FHWA REG. NO.	STATE	PROJECT NO.	YEAR	SHEET NO.	TOTAL SHEETS
7	KANSAS	STP-N012(901)	1999	42	131

KANSAS DEPARTMENT OF TRANSPORTATION
448-89404
PAWNEE AVENUE
E. of Rock to WEBB
WATER LINE RELOCATION

PLAN - MAIN 4
SCALE: 1 : 500

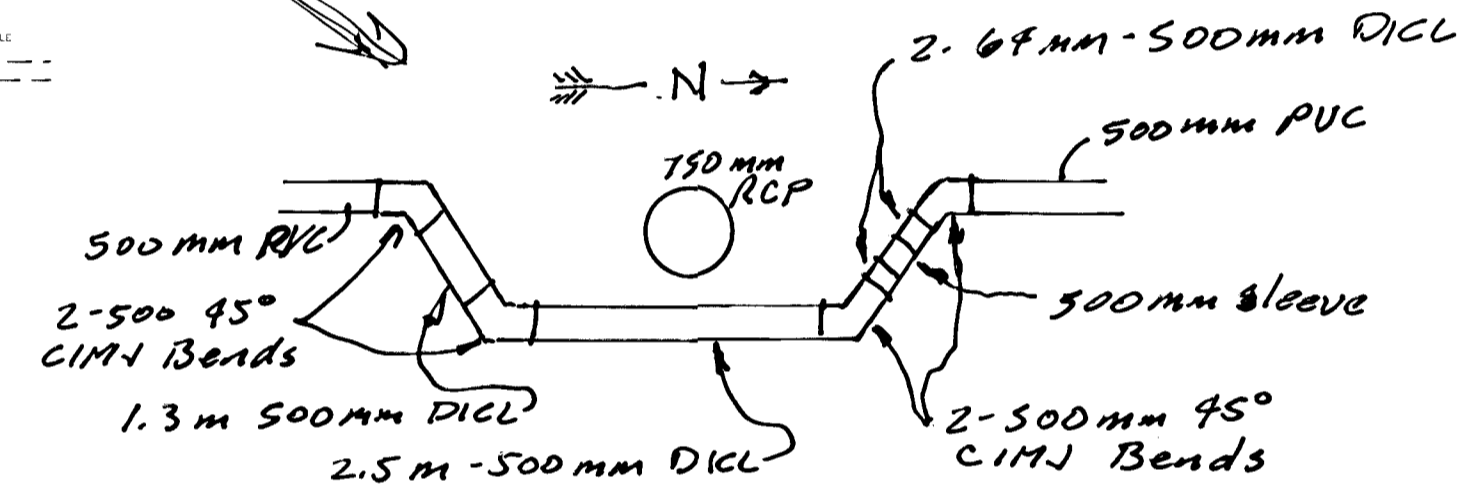
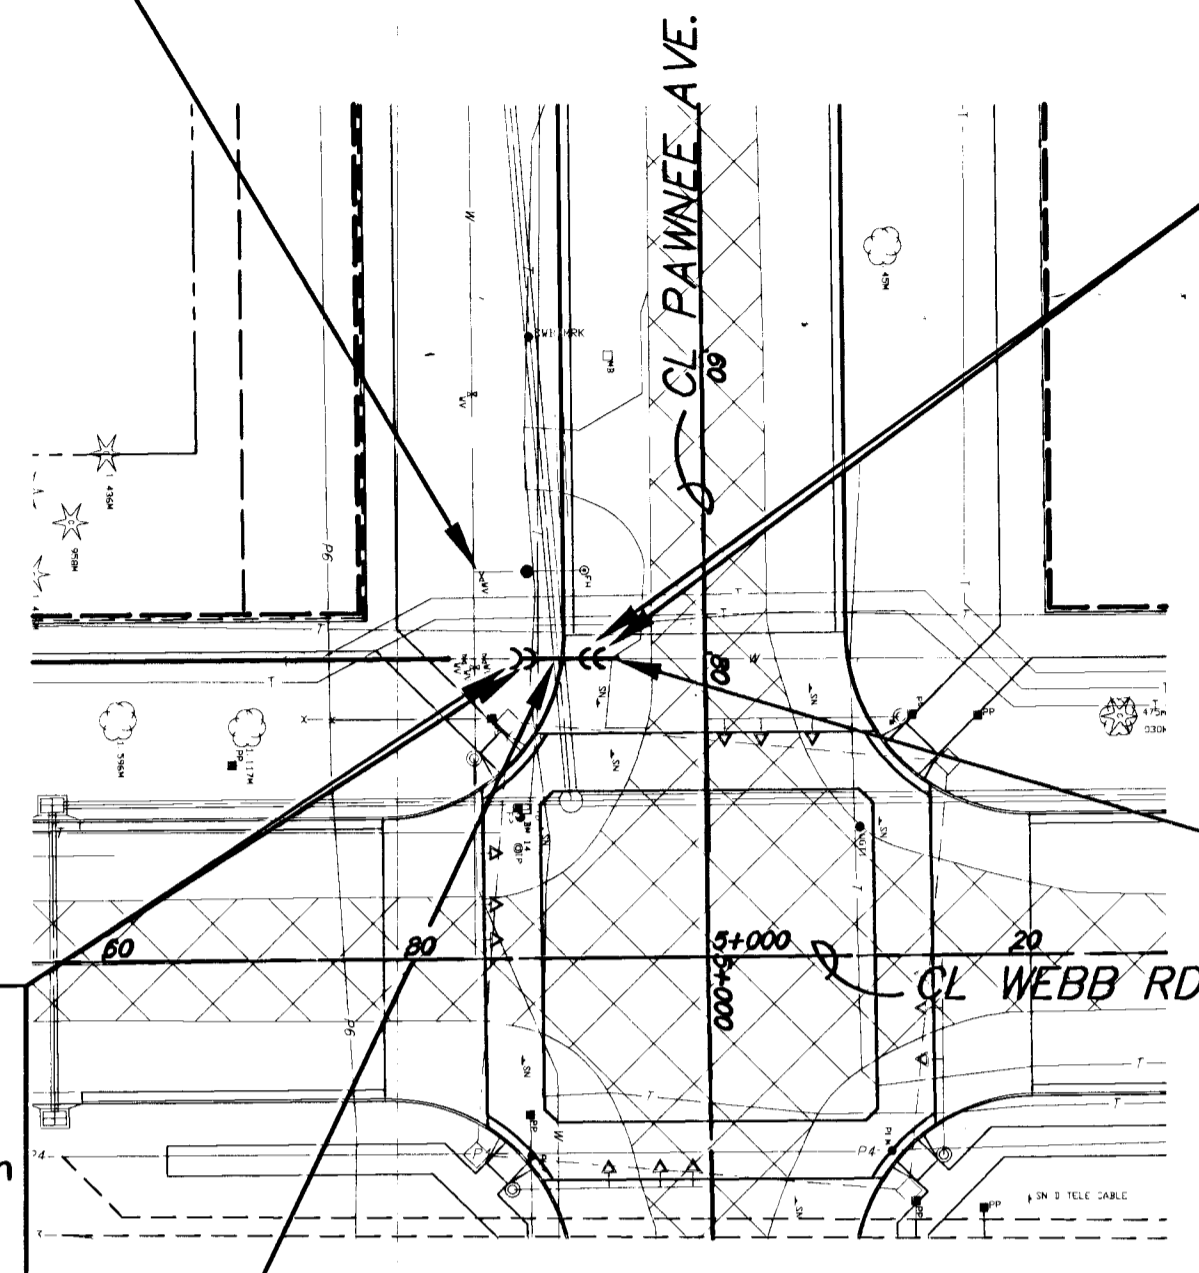
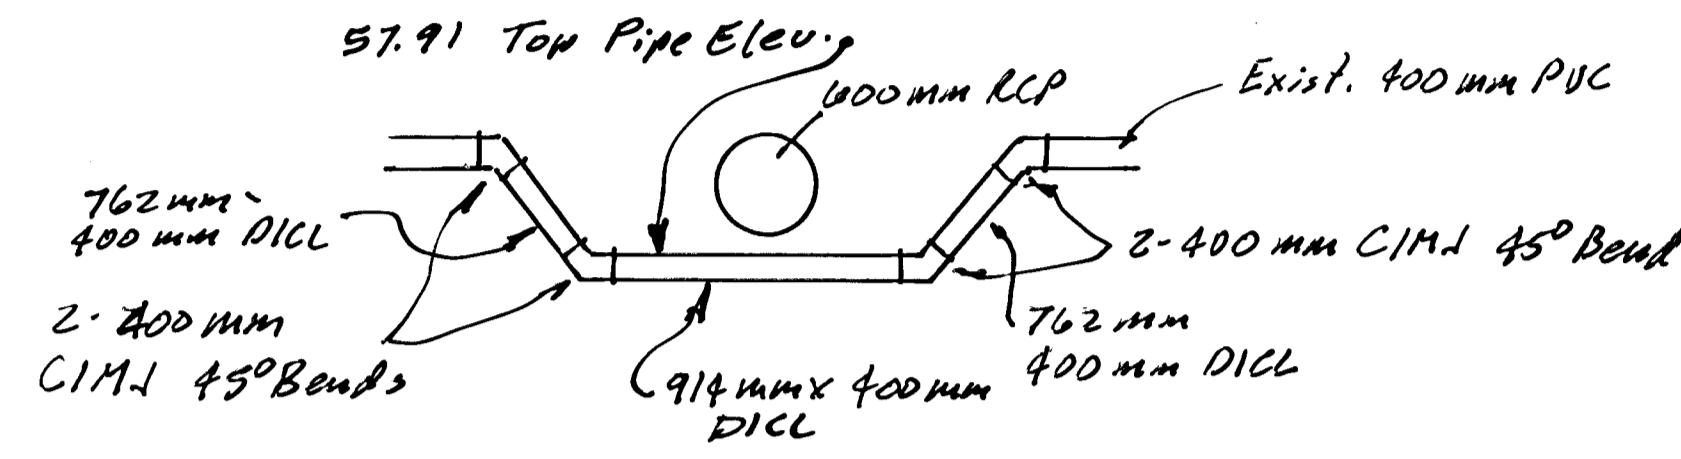
Added Waterline Correction
@ Sta. 4+723.57, 14.0'm Rt
(to accommodate SWS Revision)

PAWNEE BL STA. 4+974.4, RT. 7.62m
REMOVE EXIST. FIRE HYDT.
BRANCH & VALVE. ROTATE HYDT.
TEE 180° TO THE SOUTH &
REINSTALL VALVE & FIRE HYDT.
USING 150mm MJ ANCHOR COUPLINGS,
SET TO GRADE & BLOCK
